Noyac Bay

SUITE 311
ORIGINAL LAYOUT
INVENTORY SUITE

* SUITE 311 * (INVENTORY SUITE)

- NEW PLAN
- REMOVED DEN
- REVISED KITCHEN

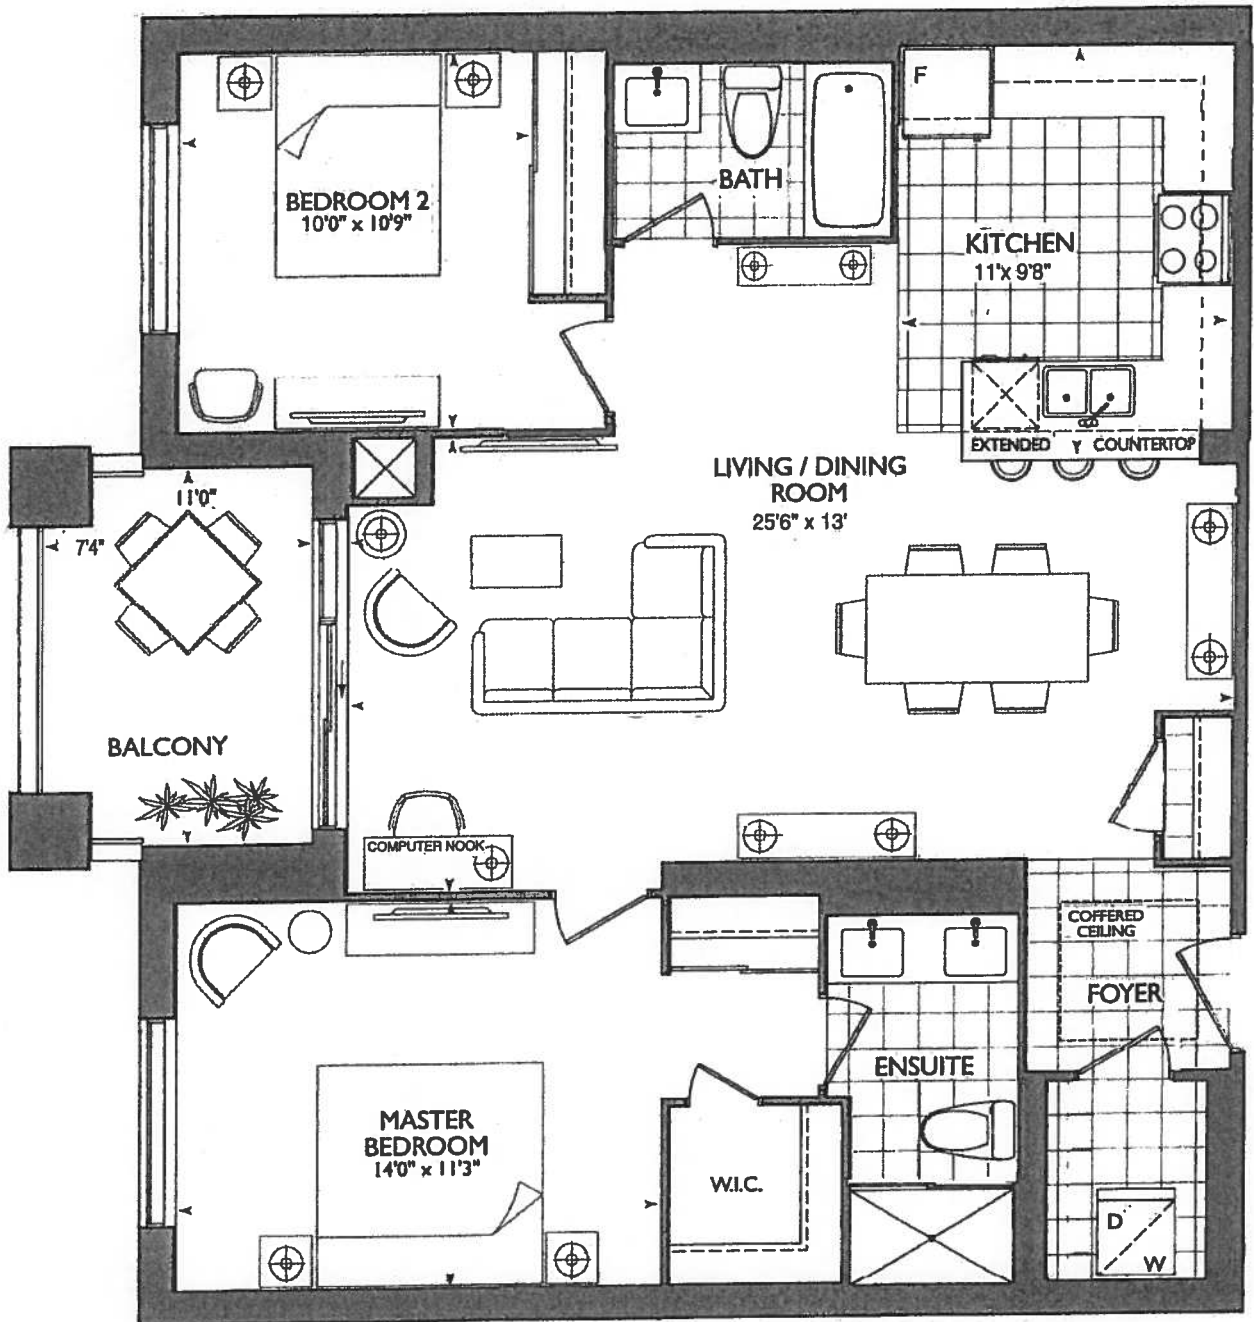
* KITCHEN *

CHOICE OF STD. KITCHEN LAYOUT WITH
STD. APPLIANCE PACKAGE

OR

CAN UPGRADE AT DECOR CENTER

- (x2) CAPPED PENDANT
- (x1) PLUG PENINSULA
- (x) PUCK LIGHTS

*SEE ATTACHED UPG.

#1- KITCHEN LAYOUT WITH 1ST UPG.
APPLIANCE PACKAGE

311

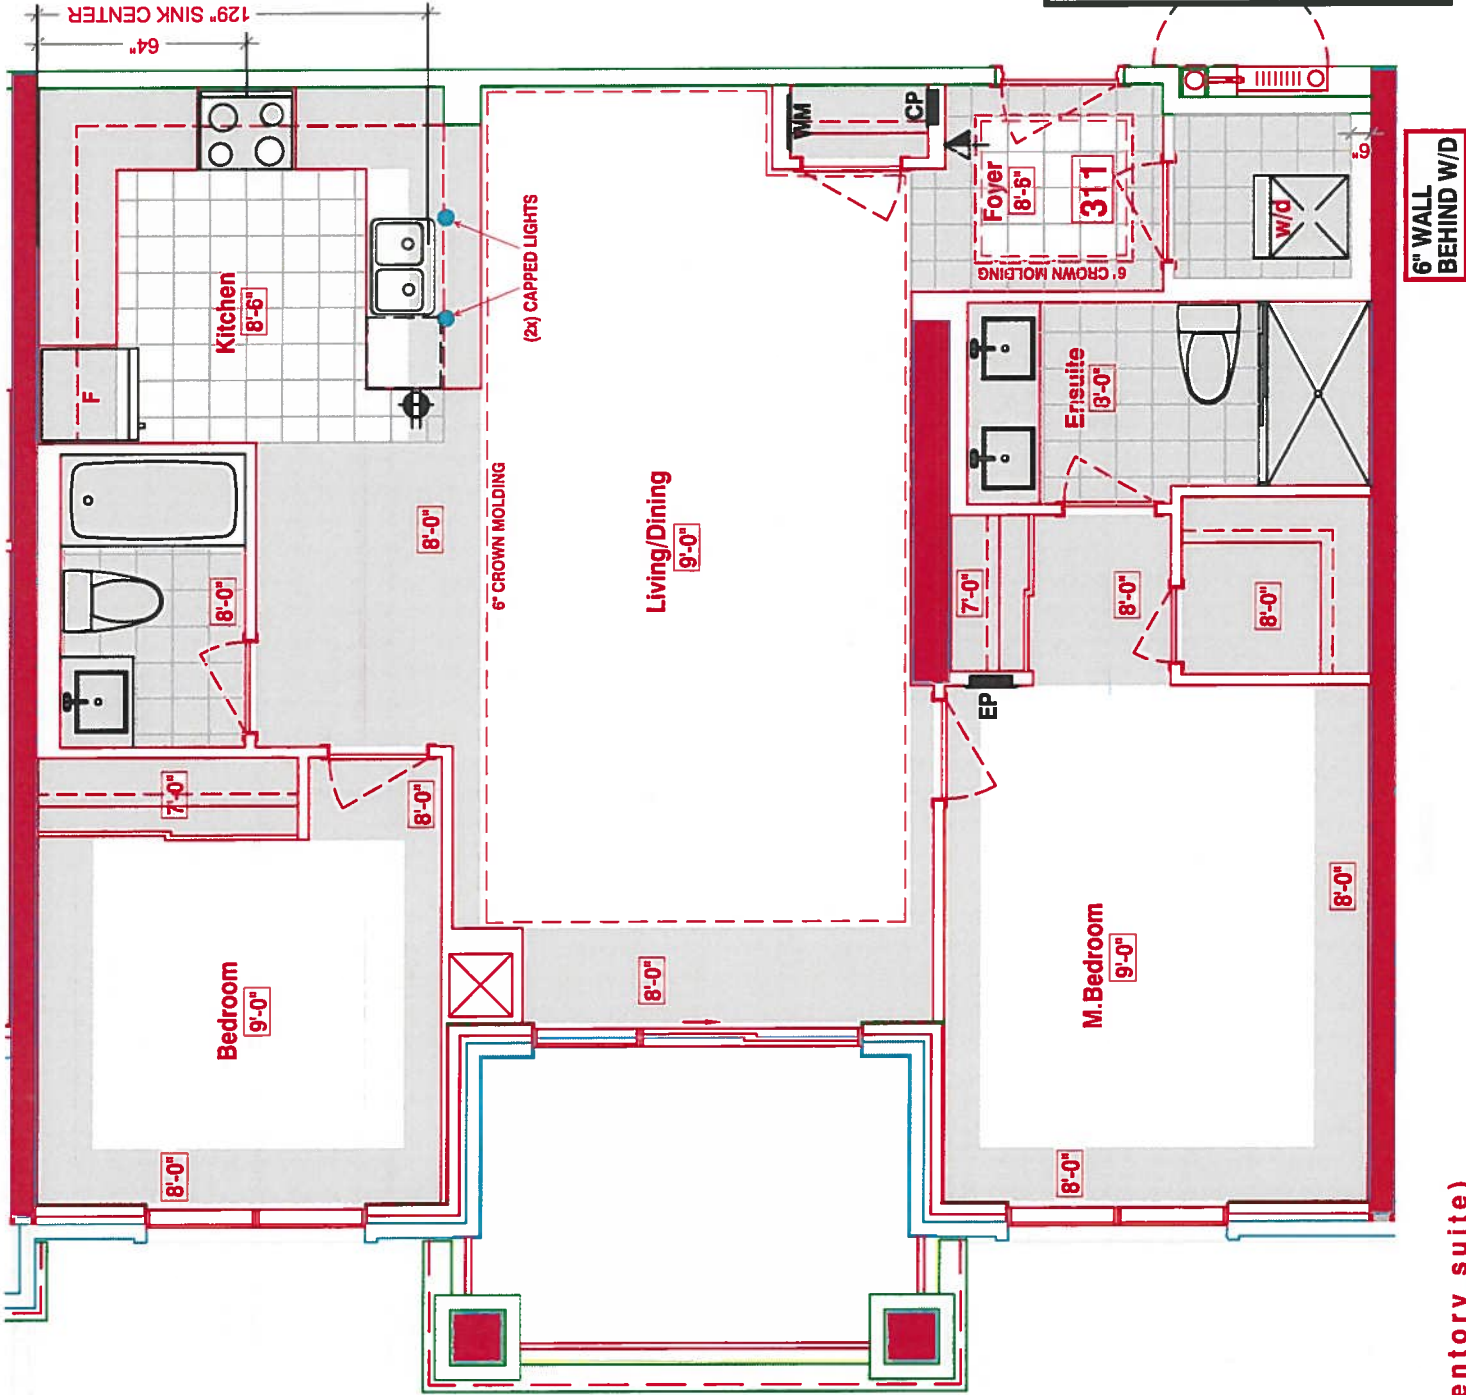
*REVISED LAUNDRY DOOR SWING &
ENSUITE WALL AS PER THIS BROCHURE

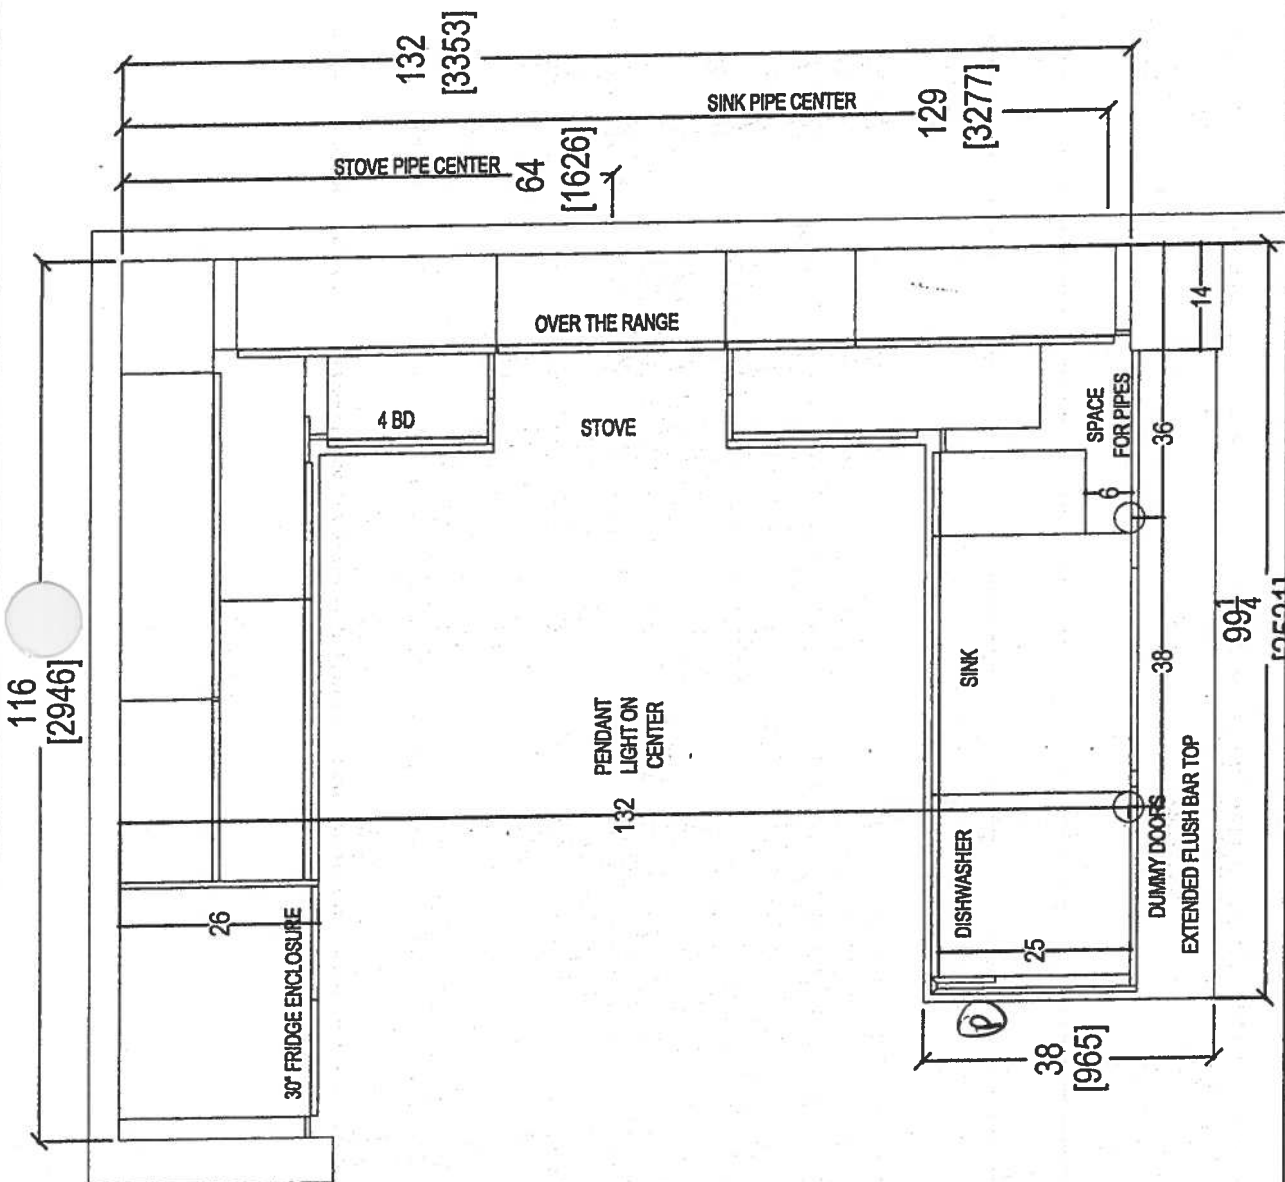
- STD KITCHEN LAYOUT
- STD APPLIANCE PKQ.
- (x1) = PLUG PENINSULA
- (x5) = PUCK LIGHTS
- (x2) = CAPPED PENDANT LIGHTS OVER PENINSULA
